ADDENDUM No. 1

INVITATION TO TENDERERS No.: 1220-020-2023-003

TITLE: GUILDFORD RECREATION CENTRE ROOF
REPLACEMENT

ADDENDUM ISSUE DATE: JUNE 1, 2023

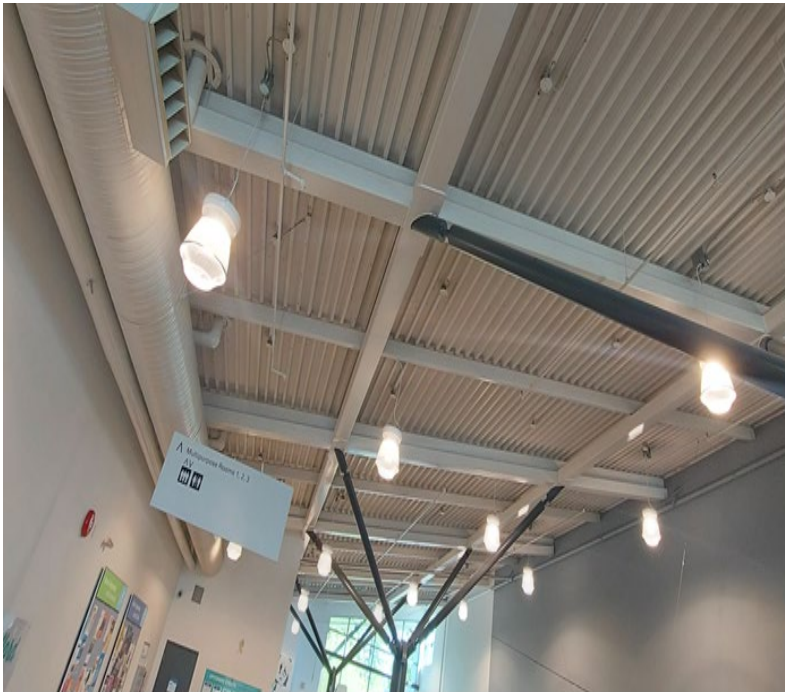
Q2. What taper insulation type is required? The assemblies call for taper ISO, one area of specs call for taper ISO but another area calls for taper EPS.

A2. On Part F, Specifications, under SBS Modified Bitumen Membrane Roofing section 2.1, .8, Remove;

“Expanded polystyrene tapered insulation with no CFCc and HCFCs.

.1 Plasti-span by Plastifab”

and replace with,

“Tapered insulation: Closed-cell, polyisocyanurate foam core insulation Type 2 or Type 3 bonded on each side to fiberglass facers during the manufacturing process, dimensional stability to ASTM D2126 <2% in all conditions. Acceptable materials:

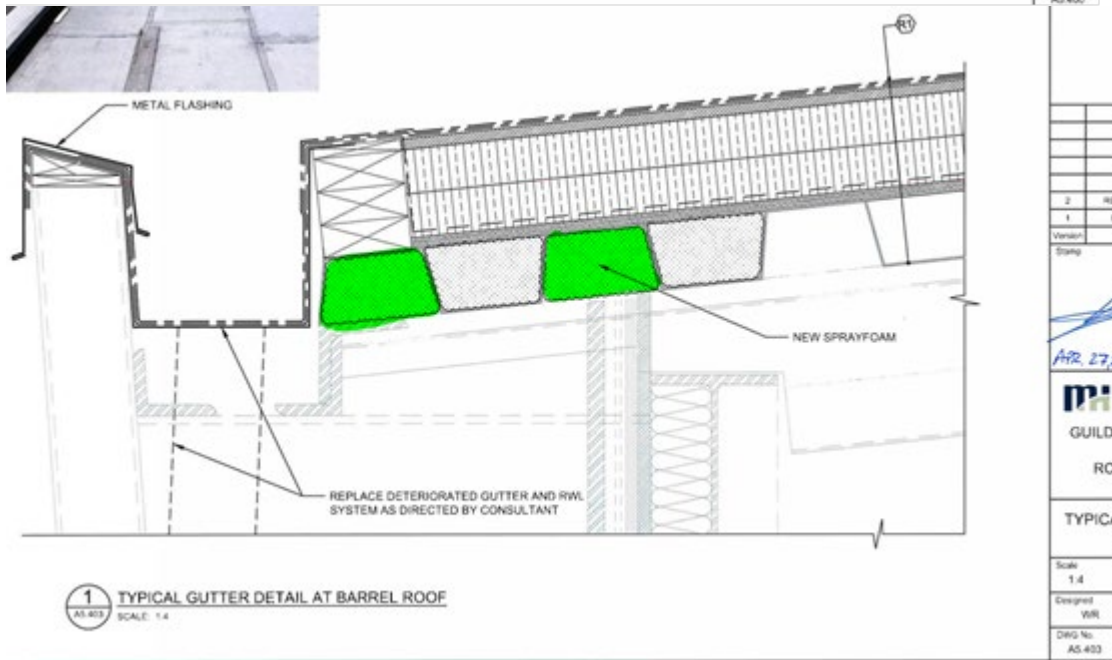
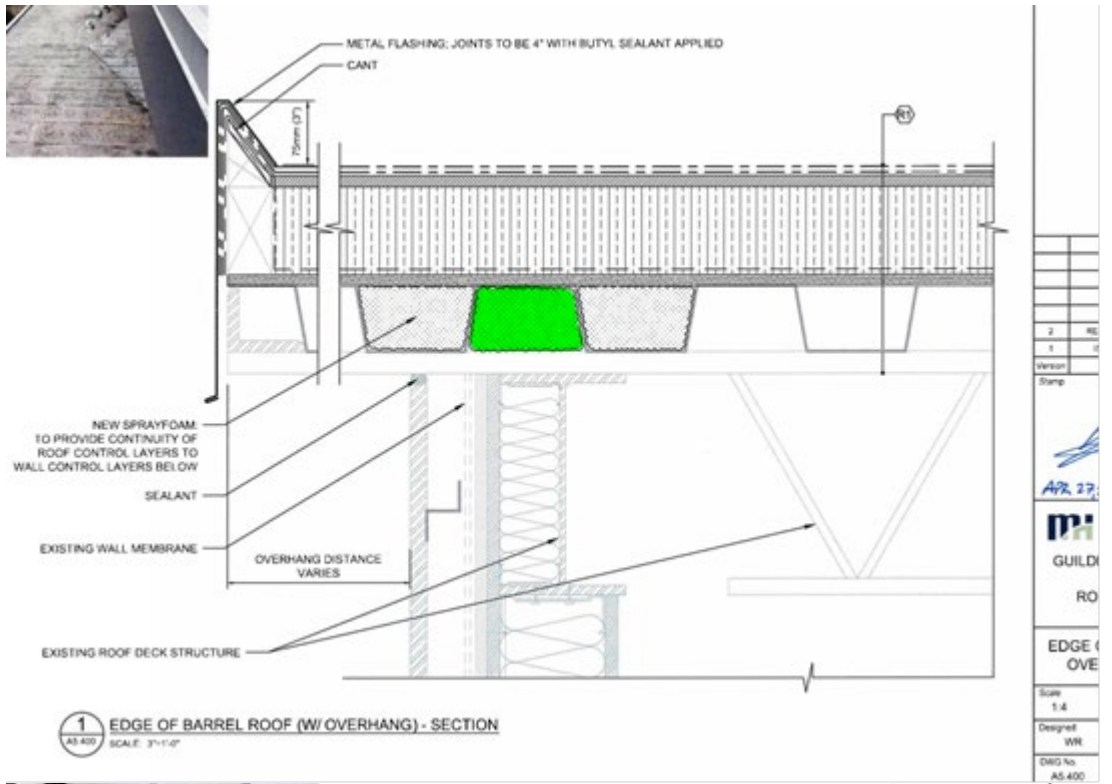
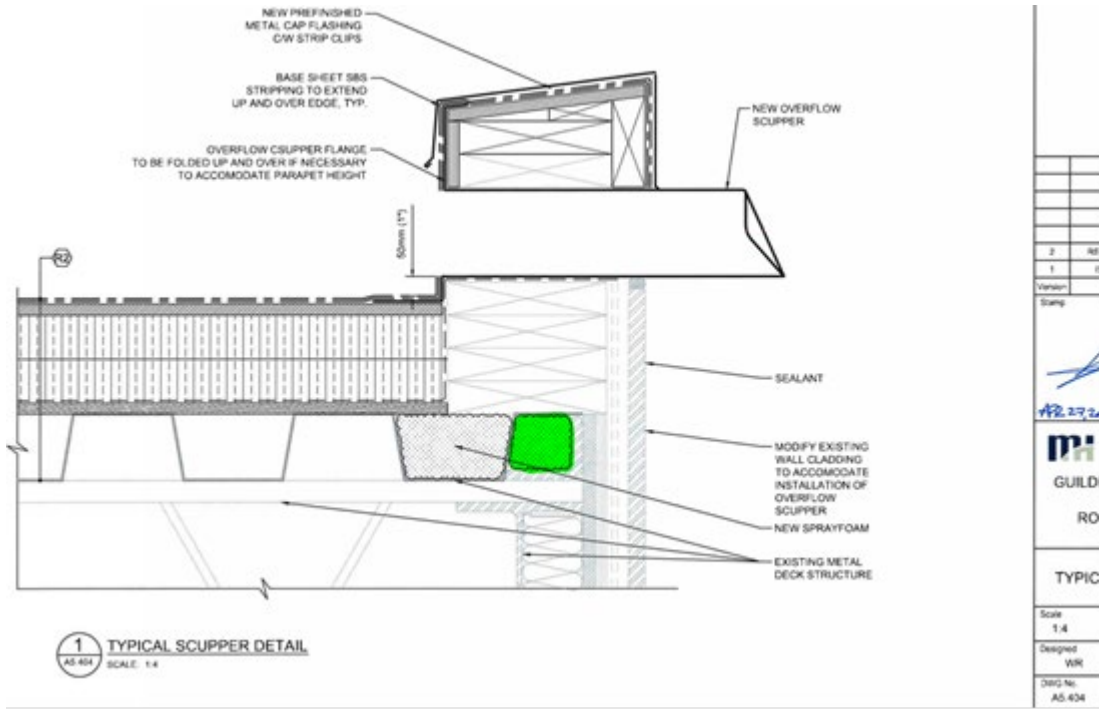
Q8. Some of the spray foam details appear to be impossible to access. Please provide instruction for application of the spray foam locations highlighted below:

A8. Please price what is shown in the drawings. A site evaluation will be conducted at time of tear-off for methodology and limitations of this detail.

1 ROOF PLAN With Dimensions
A1.101 SCALE: 1:400

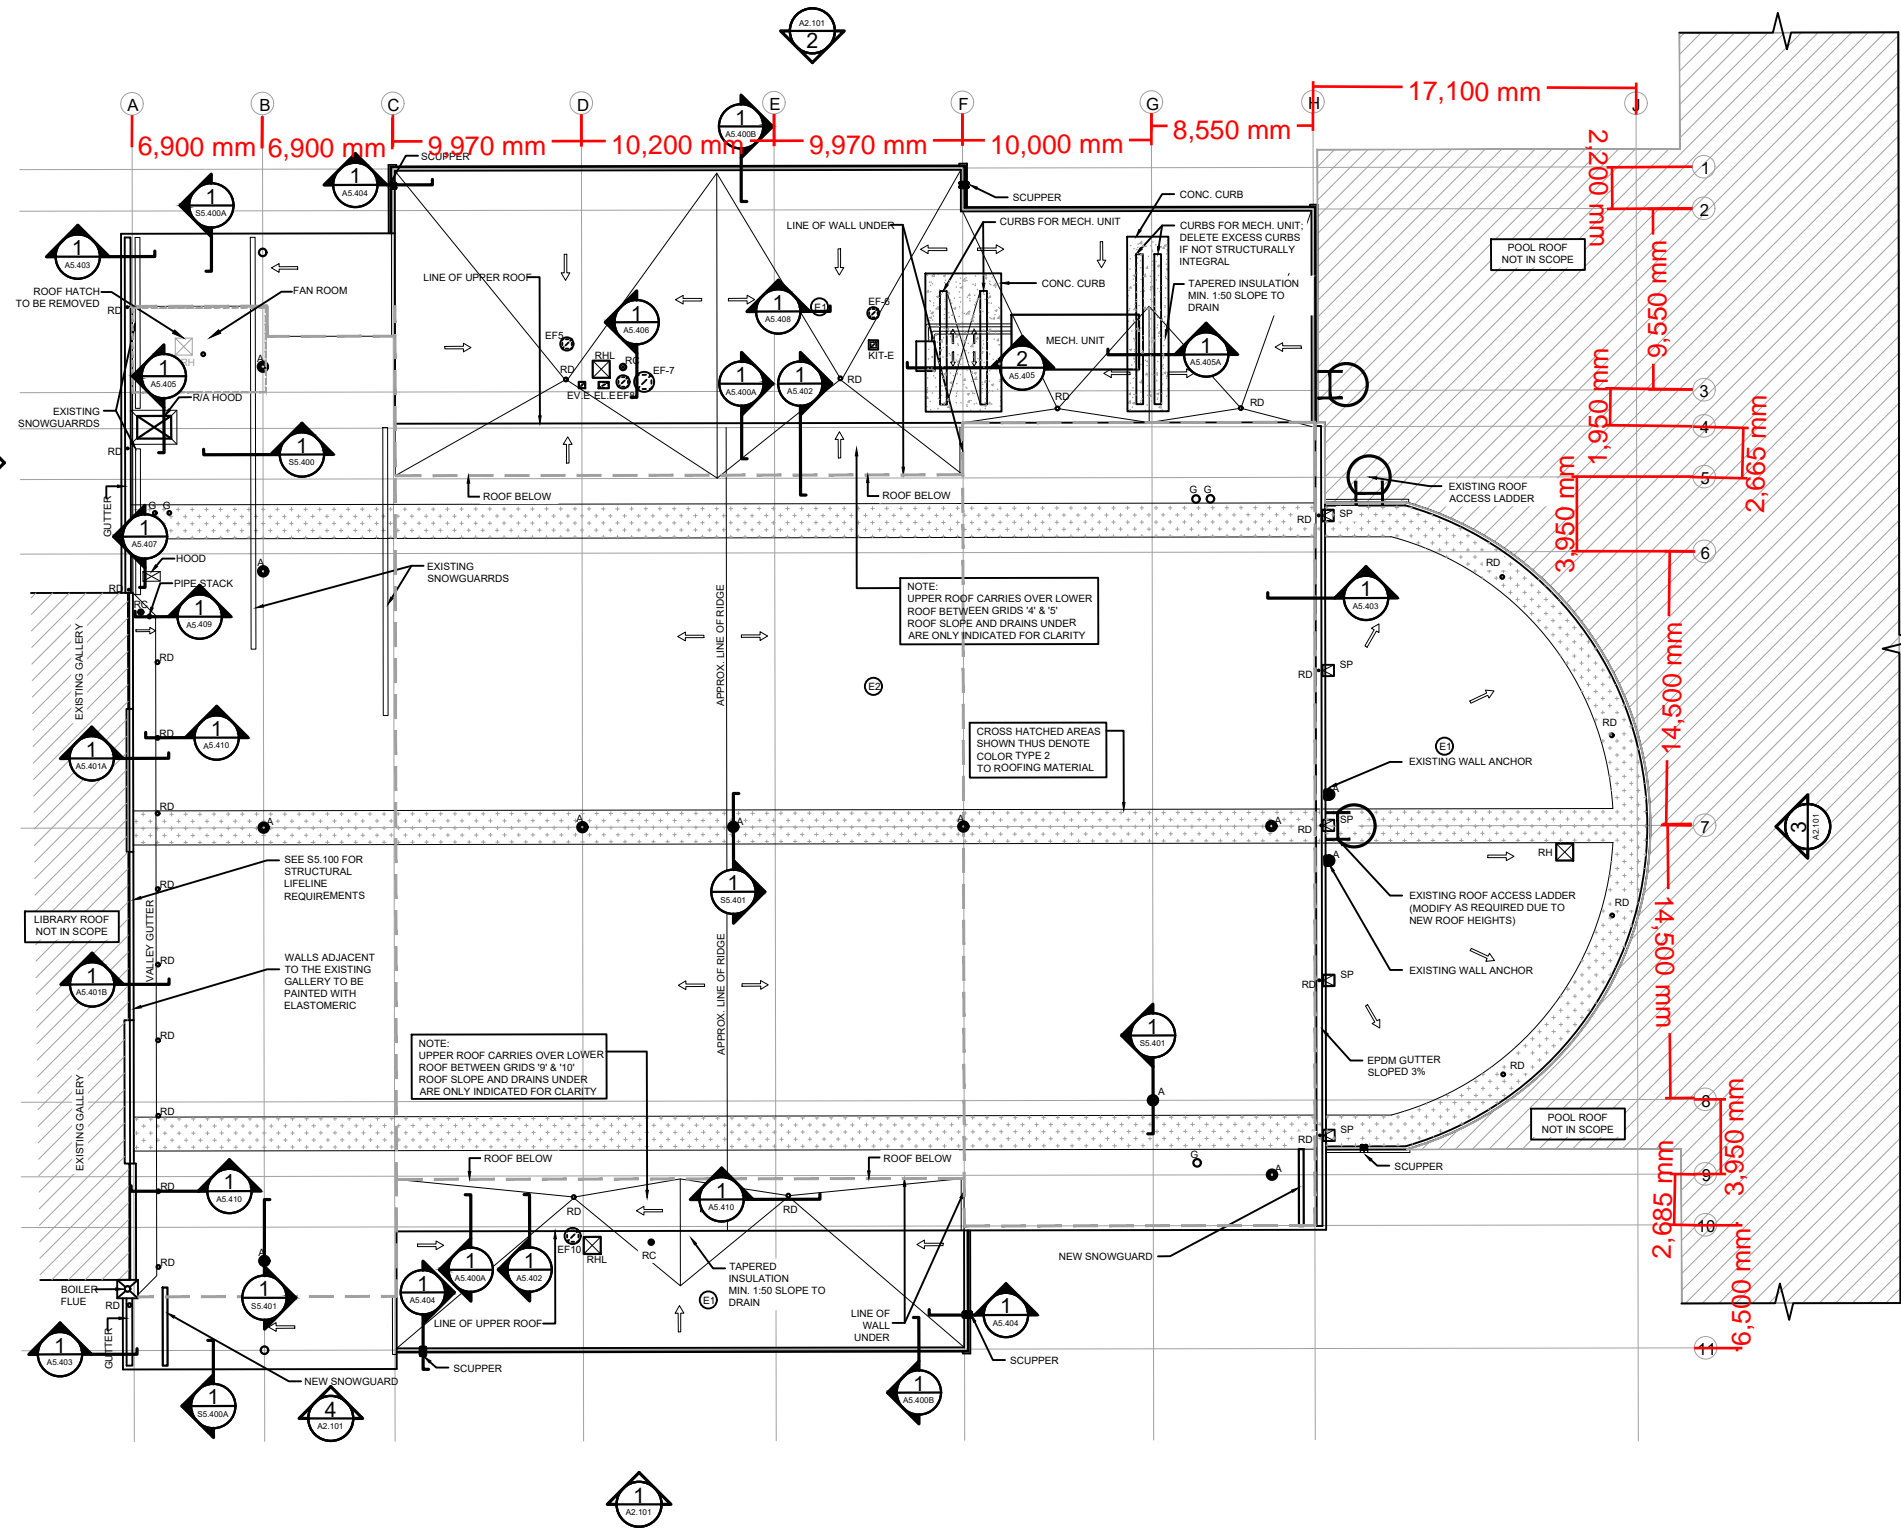
Q1. Will a new drawing of the lower South roof (we didn't get access during the site meeting) be provided in an addendum with proper dimensions?

A1. See Attachment No. 1 Lower South Roof, to Addendum No. 1 on page 8.
